# Edenville Dam Emergency Inspection Report

**June 19, 2020**

**Dam Name:** Edenville Dam

Re: Dam Emergency Inspection Report  
**Edenville Dam**  
**Edenville, Midland and Gladwin Counties, MI**  
**TRC Project No.: 398511**

*Photo 45: Approximate location of tension cracks and eroded area previously remediated by Boyce Hydro.*

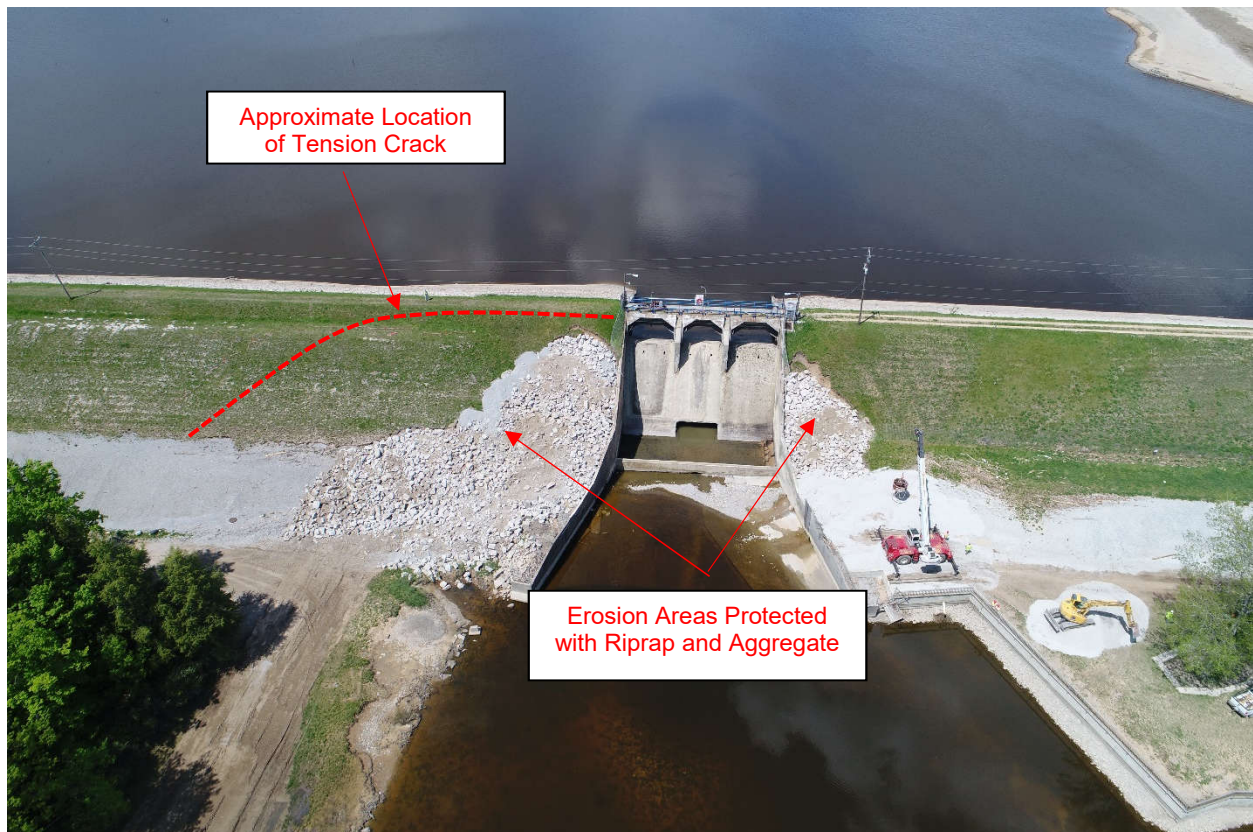
Tension cracks and surface sloughing was observed to the immediate right and left of the downstream slope of the Tobacco Spillway, see Photo 45. It is understood that tailwaters developed within the Tobacco River when the dam breached causing erosion damage to the bottom portion of the downstream slope where said cracks and surface sloughing was observed. The toe erosion created a loss of buttress support of the slope and the waves and precipitation during the storm inundated and softened the ground surface, thereby, weakening the slope causing the movement. It is anticipated that the sloughed material is a “sliver fill” overlay that was placed by Boyce Hydro at the request of FERC in 2014 and 2015 for the purpose of flattening the slope so that acceptable factors of safety could be achieved. As an

emergency effort, Boyce Hydro had the erosional areas backfilled with riprap and aggregate. Although it now may be more difficult to determine the location of a seep if one occurs, the riprap will protect the slope from erosion. Boyce Hydro also installed gauges around June 5, 2020 to monitor the tension cracks for additional movement, see Photo 46. Boyce Hydro indicated that since its installation the gauges have indicated the cracks are not increasing in size. These cracks should be backfilled with soil or bentonite to “seal the voids” to prevent water from entering the cracks and potentially weakening the embankment.

Under the conditions observed at the time of TRC’s inspection, the slope appears to be stable from a global perspective. Until repairs can be made to the Tobacco Spillway and adjacent slopes, it is recommended that the tension cracks be monitored by Boyce Hydro and that survey hubs be installed along the slope (at the crest, toe, and midslope) to monitor the slope for additional movement – the gauges and survey hubs should be monitored on a weekly basis. If the slope conditions worsen, the dam may need to be breached to the right of the spillway area so that the loading on the spillway and embankment is reduced by lowering the reservoir water level and passing the flow to the original Tobacco River alignment. Boyce Hydro will need to present this approach to EGLE for their review and concurrence if this is to be considered.

- C-6 The tension cracks that have developed to the right of the Tobacco Spillway should be backfilled with soil or bentonite to “seal the voids” to prevent water from entering the cracks and potentially weakening the embankment.
